**Annex 2A**  
**Final Working Paper for Treatment Options**  
**for San Shek Wan STW**

**Agreement No. CE 55/2009 (DS)  
Outlying Islands Sewerage Stage 2  
– South Lantau Sewerage Works  
– Investigation**

**Working Paper – Treatment Options  
for San Shek Wan STW (Final)**

**2888/B&V/0006/Issue 1**

Drawing no.  
**382888/B/SKH/00003**

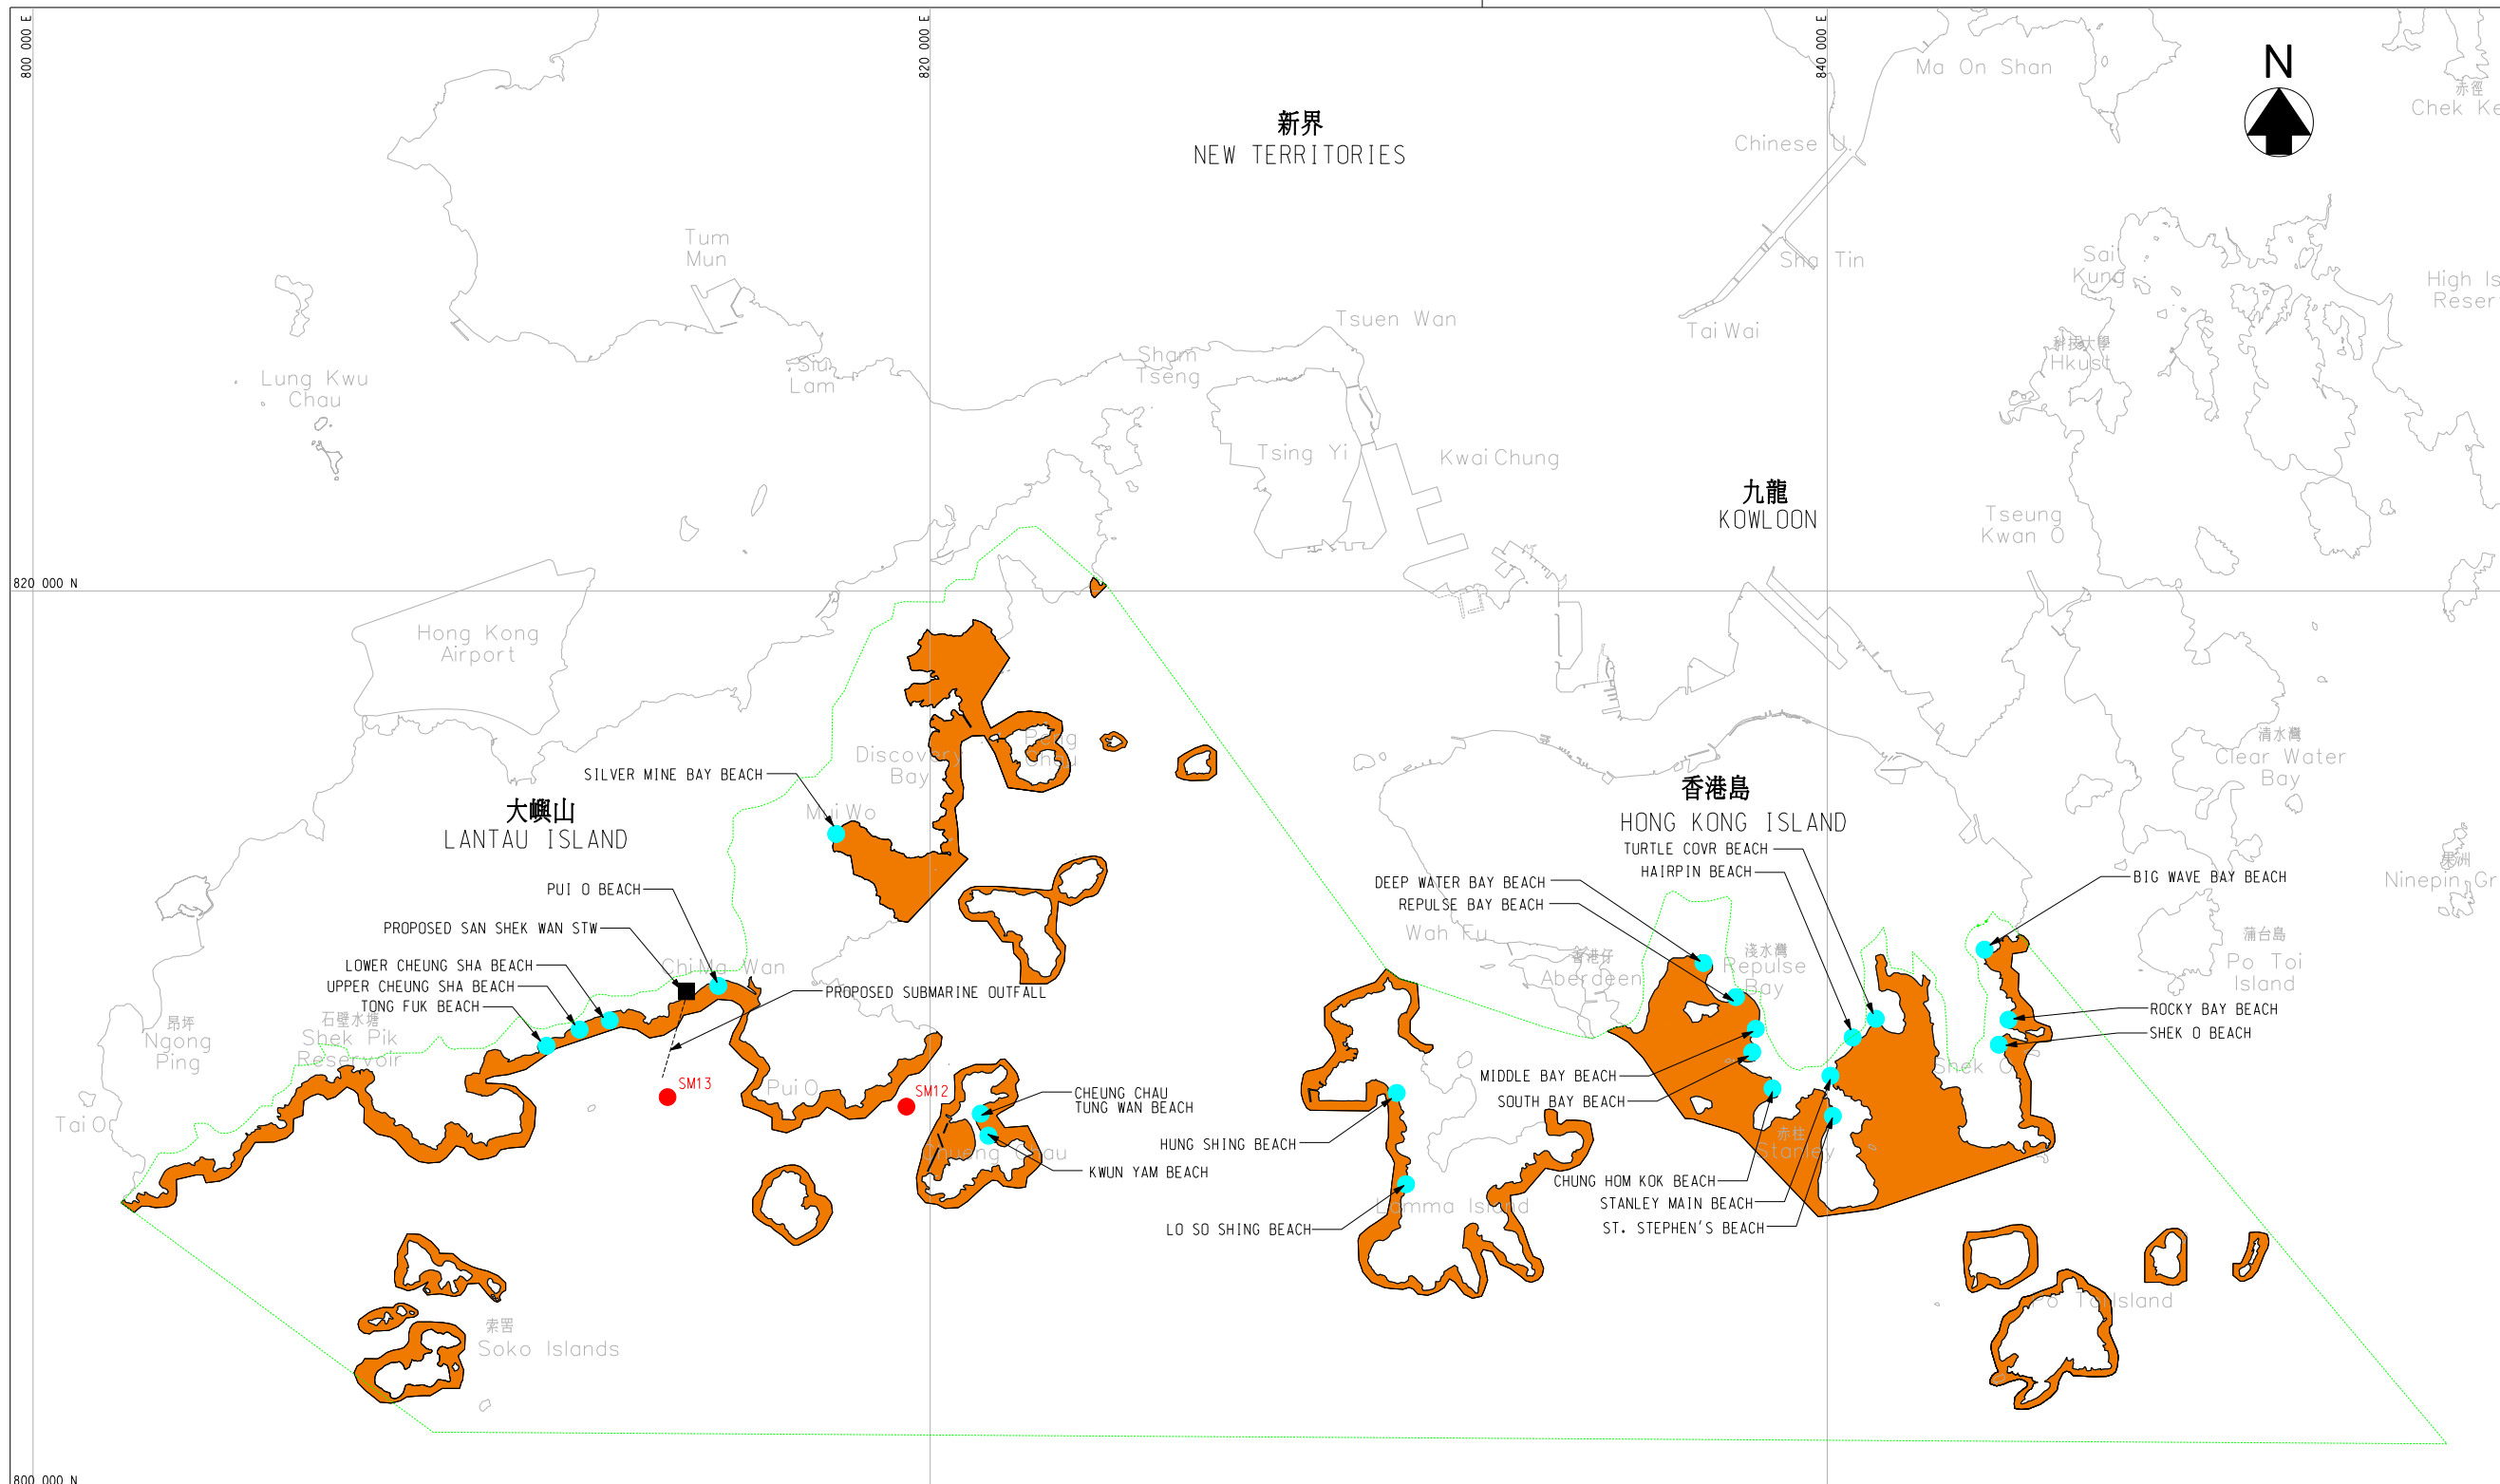
Comment	Response
<b>Section 3</b>	
Before this section, it would be better to add a section for describing about existing water quality of Southern Water Control Zone including (i) quality of the nearest marine water stations (i.e. SM12 & SM13); (ii) quality of bathing beaches; and (iii) influent flows and loads (weekdays and public holidays) in existing and ultimate scenario.	The information is included in Section 2 of the Paper as supplementary background information. Influent flows and loads have been included in Appendix A.
Section 3.1 is not found in the paper. Please check if it is missing out or just a typo error in the numbering system.	Noted and amended.
<b>Section 3.2</b>	
Paragraph 1 – Should “South Water Control Zone” be read as “Southern Water Control Zone”?	Noted and amended.
For clarity and ease of reference, it would be better to provide a drawing showing the boundary of Southern Water Control Zone with delineation of secondary contact recreation zone and bathing zones of gazetted beaches viz. Pui O beach, Cheung Sha beach and Tong Fuk beach, the nearest marine water monitoring stations (i.e. SM12 & SM13), and the proposed San Shek Wan STW associated with submarine outfall.	Noted. Drawing has been included.
